# SAM G55 SERIES

## SAM G55 Series Family Silicon Errata and Data Sheet Clarification

## Data Sheet Clarifications

## 8. Module: Transmitter Operations

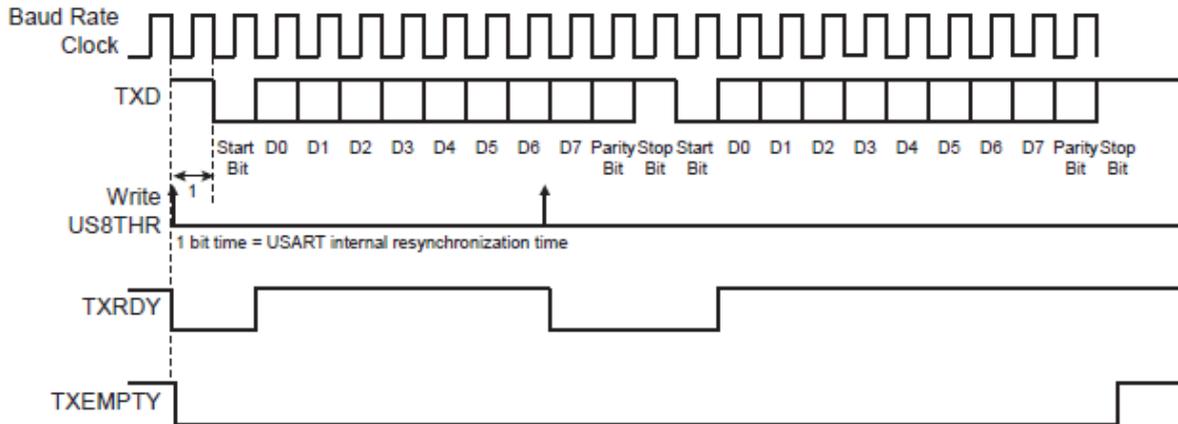
Figure 30-6 is incorrect. The corrected figure is as follows:
